North Dakota Department of Transportation

ADDENDUM 1 – JOB 23

TO: All prospective bidders on project NH-NHU-4-083(111)200, Job No. 23 scheduled for the November 18, 2016 bid opening.

Project Information		
Project: NH-NHU-4-083(111)200		PCN: 18912
Location: Minot, Ward County		
Date:10/14/16		Lead Designer: Burns & McDonnell
Bid Opening Date: 11/18/16		JOB#: 23 Addendum#: 1
Distribute to: -Grp-DOT Bids Addenda (dotbids@nd.gov)		
Section	Sheet	Description of Change
2	1	<ul style="list-style-type: none"> Deleted Section 85 Landscaping Added Section 130 Guardrail Updated Section 6 (page 1-5 Notes and page 6 Environmental Notes) Added SP 0386(14) Removed SP 0363(14)
2	2	<ul style="list-style-type: none"> Added Guardrail Standard Drawings D764-1,5,22
4	1	<ul style="list-style-type: none"> Updated extents of imprinted concrete Removed sidewalk South of the bridge, West of US-83 Updated edge of pavement due to guardrail addition
6	ALL	<ul style="list-style-type: none"> Updated plan note on 100-P01 to include coordinating use of Temporary Construction Easement between projects Added additional details/updates to 105-P02 Adding 105-P02 shifted all other notes and all sheets had to be repr

Revised 10/14/2016	STATE	PROJECT NUMBER	SECTION NO.	SHEET NO.
	ND	NH-NHU-4-083(111)200	170	77

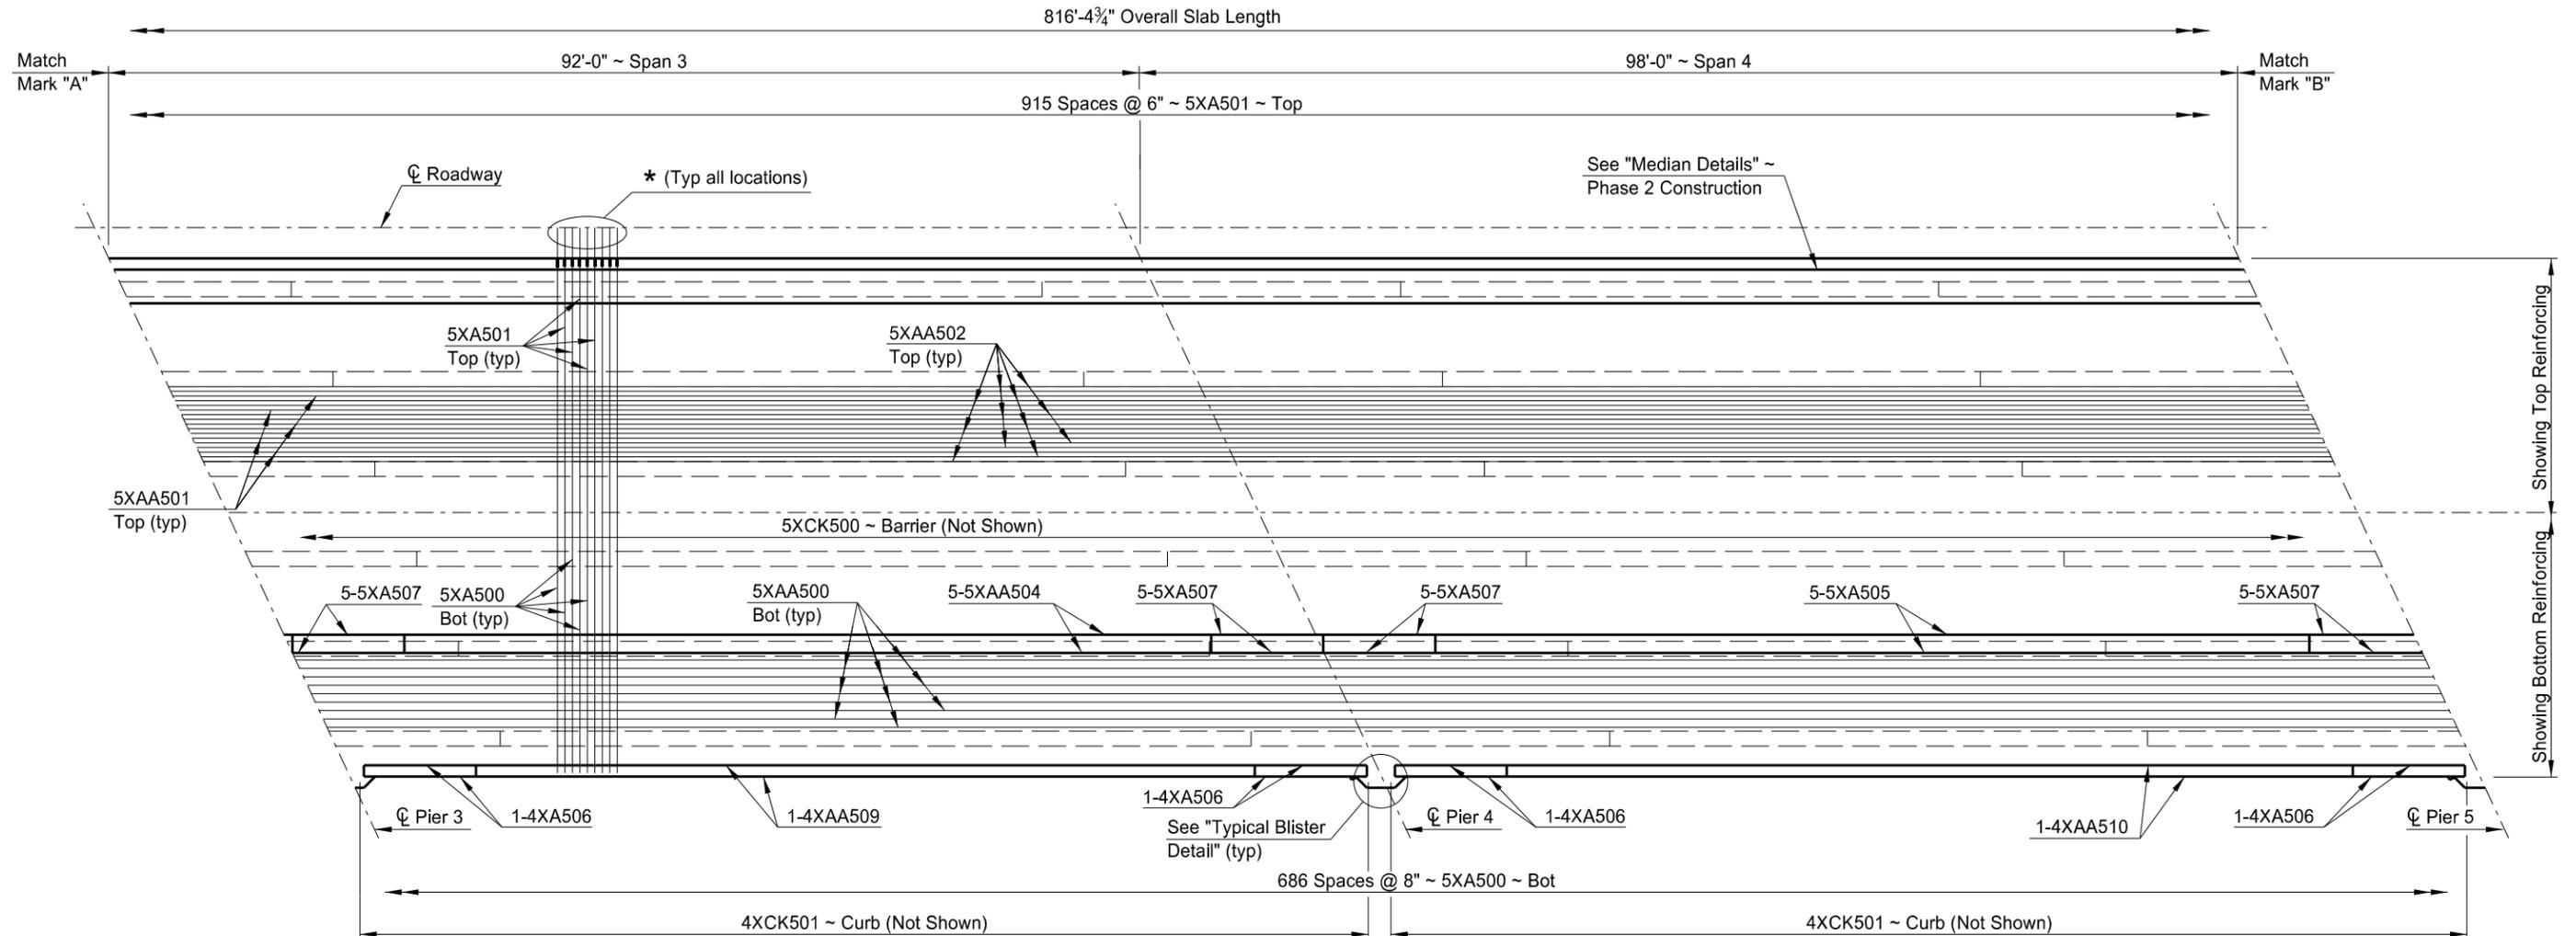
170	77	<ul style="list-style-type: none"> • Added referencing note • Adjusted referencing call out “Typical Blister...”
170	78	<ul style="list-style-type: none"> • Added referencing note • Adjusted referencing call out “Typical Blister...”
170	79	<ul style="list-style-type: none"> • Added referencing note • Adjusted referencing call out “Typical Blister...”
170	80	<ul style="list-style-type: none"> • Added referencing notes • Adjusted referencing call out “North Gateway...”
170	81	<ul style="list-style-type: none"> • Added note about rebar extension in Typ. Section
170	82	<ul style="list-style-type: none"> • Removed “Blister” from N Gateway title
170	83	<ul style="list-style-type: none"> • Rotated to accurately represent the orientation of the gateway
170	85	<ul style="list-style-type: none"> • Revised notes and finish callouts • Changed sheet title to Thematic columns
170	86	<ul style="list-style-type: none"> • Added “Transition Barrier Detail” to plan and elevation titles

STATE	PROJECT NUMBER	SECTION NO.	SHEET NO.
ND	NH-NHU-4-083(111)200	170	87

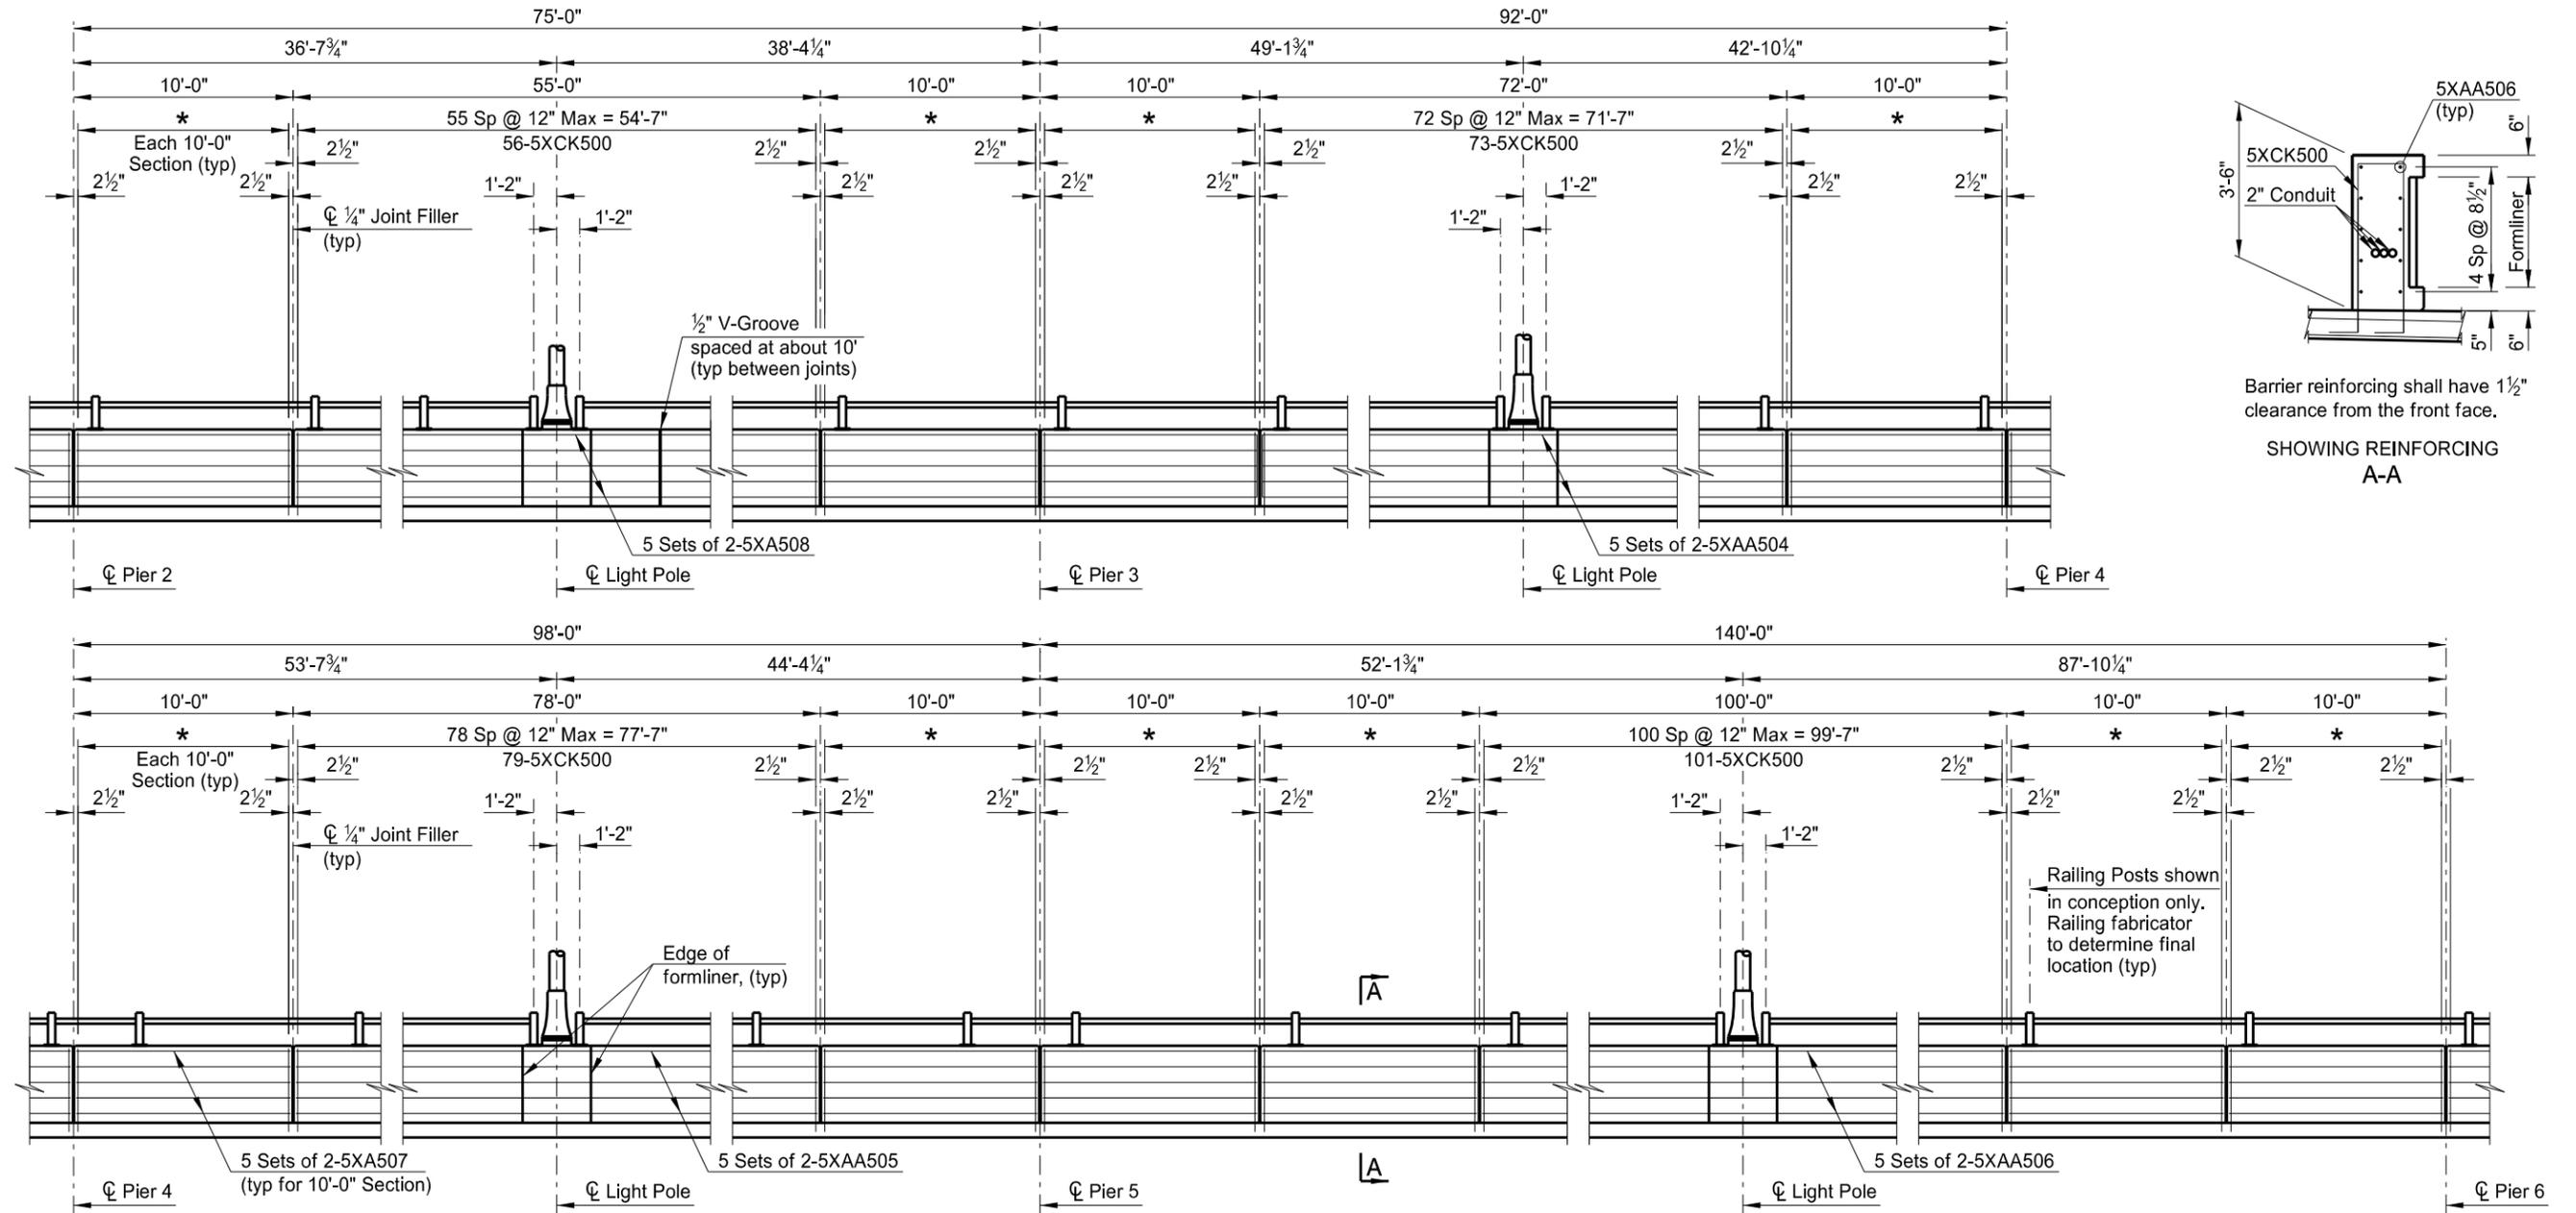
170	87	<ul style="list-style-type: none"> • Rebar callout added to section A-A
170	88	<ul style="list-style-type: none"> • Added referencing call out • Adjusted slab to stop at end of barrier • Rebar callout added to section B-B

Revised 10/14/2016	STATE	PROJECT NUMBER	SECTION NO.	SHEET NO.
	ND	NH-NHU-4-083(111)200	170	91

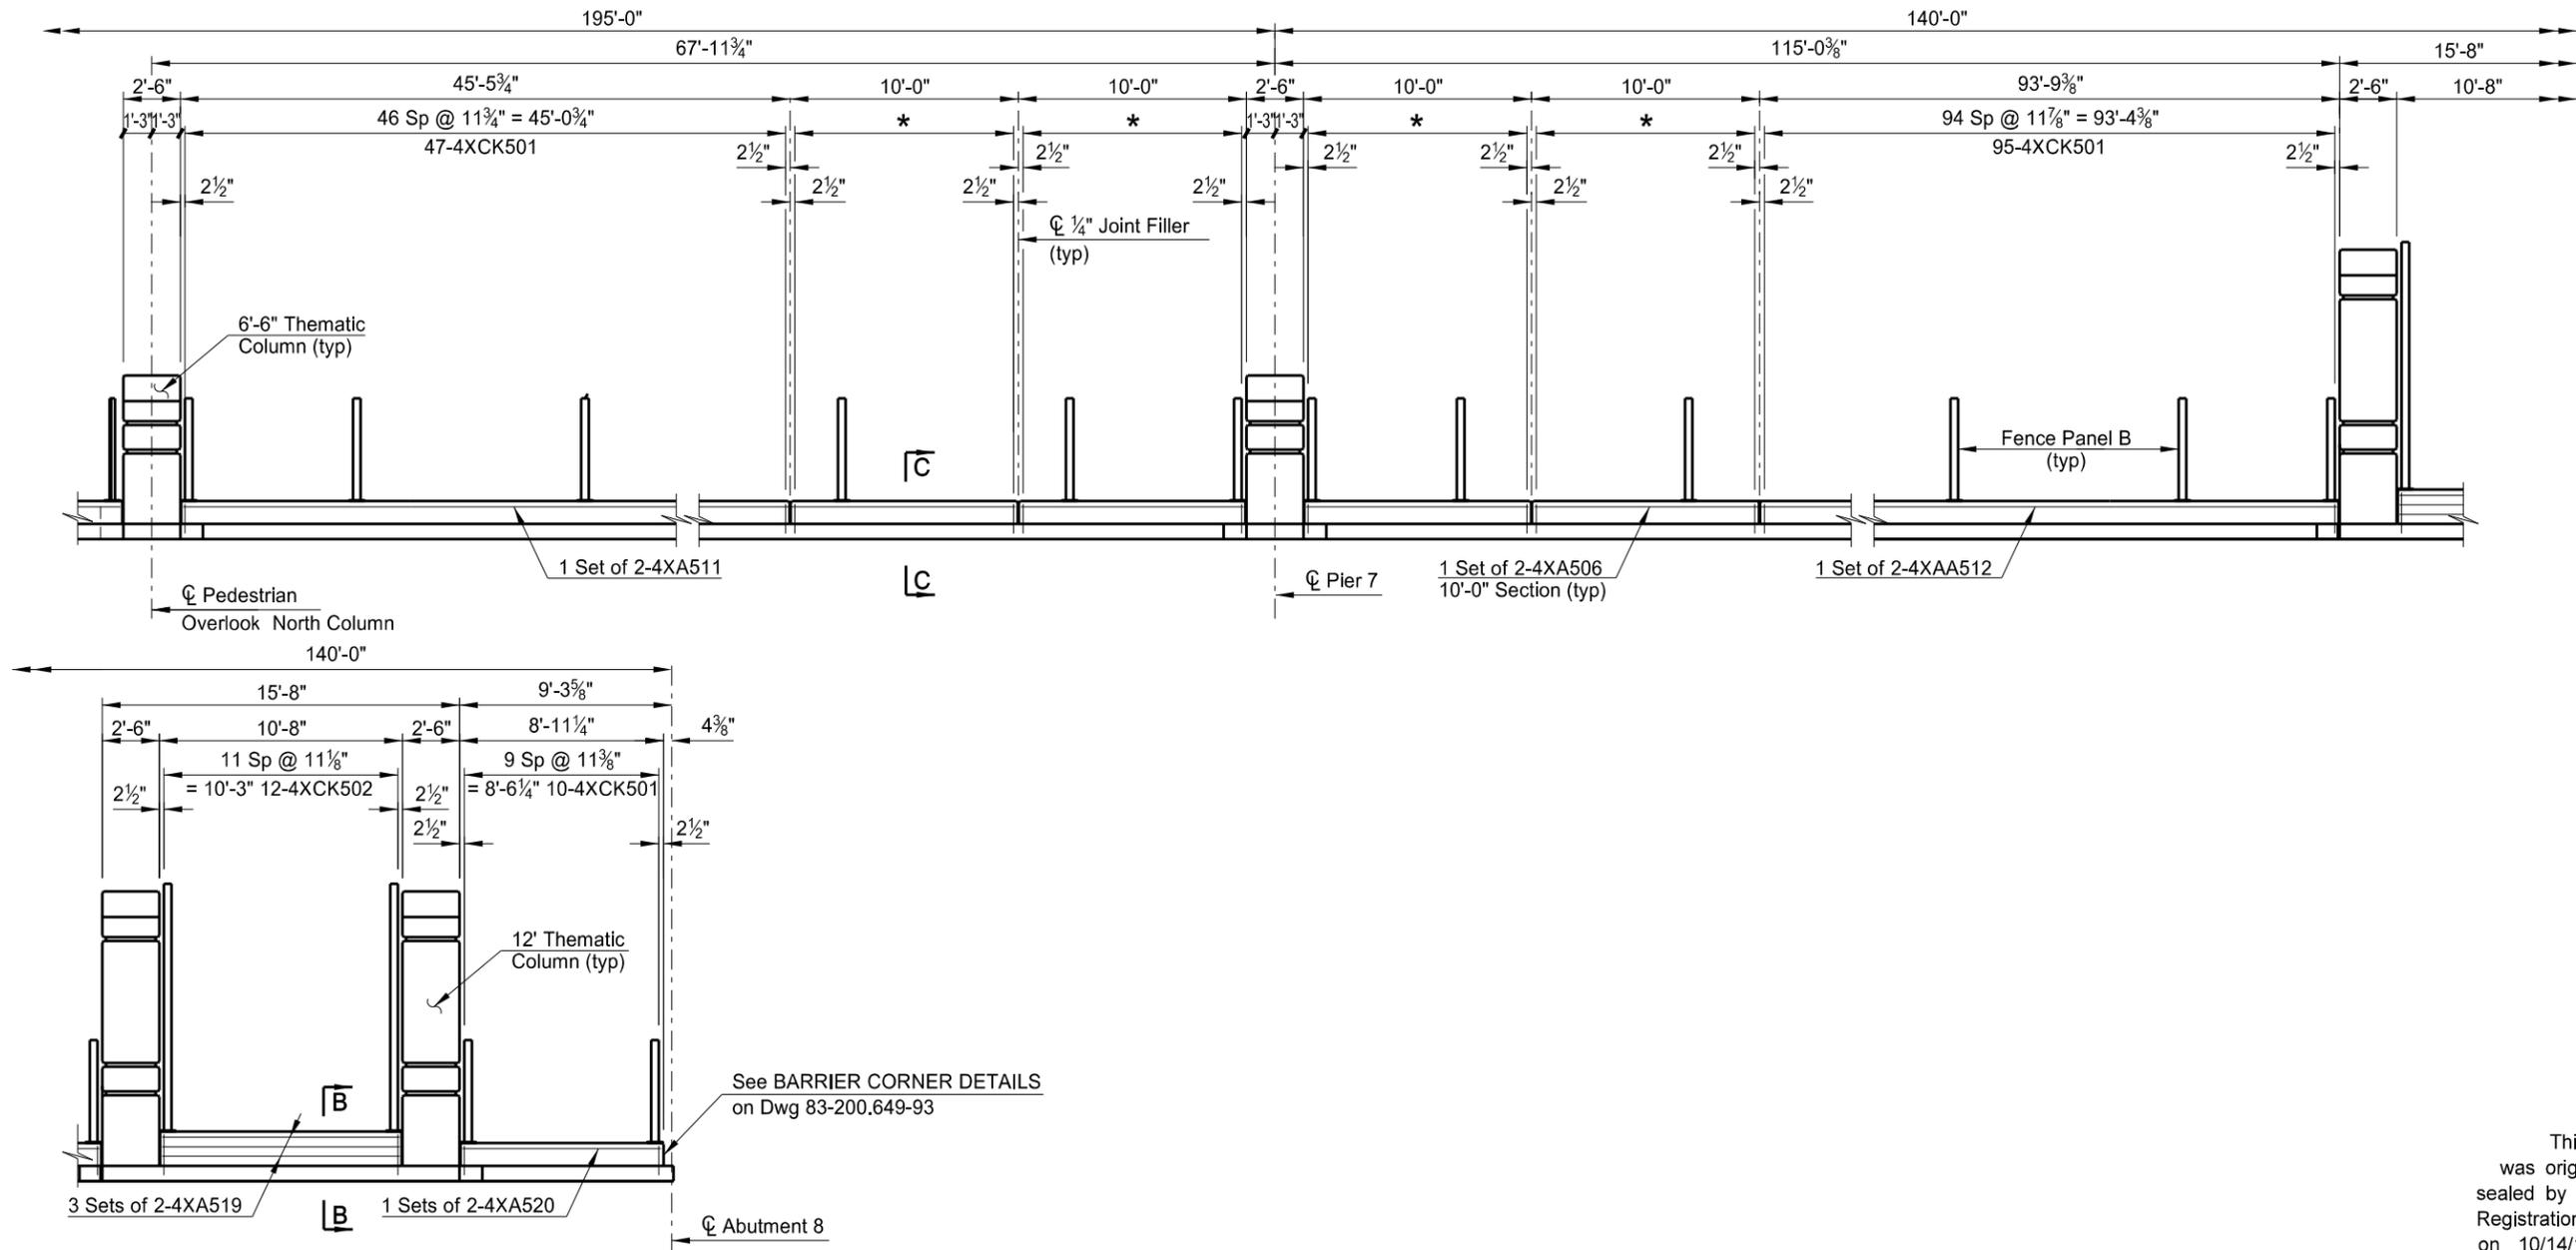
170	89	<ul style="list-style-type: none"> • Added referencing call out • Added abutment backwall • Rebar callout added to sections A-A and C-C
170	91	<ul style="list-style-type: none"> • Added referencing call out • Stop slab right after abutment 8 CL
170	93	<ul style="list-style-type: none"> • Added note referencing barrier rail expansion devices sheet • Added hot-dip galvanizing to sliding plate • Modified detail at NE corner w/ joint and fillet added
170	94	<ul style="list-style-type: none"> • Changed name of “Elevation View” and “Plan View” titles
170	96	<ul style="list-style-type: none"> • Updated for Abutment 8 rebar modifications; added note
170	97	<ul style="list-style-type: none"> • Updated for Piers 2 & 3 modifications (crash wall & footing changed, due to change from 12 piles to 9) • Added note
170	98	<ul style="list-style-type: none"> • Updated for Pier 4 modifications (crash wall & footing changed, due to change from 12 piles to 9) • Added note
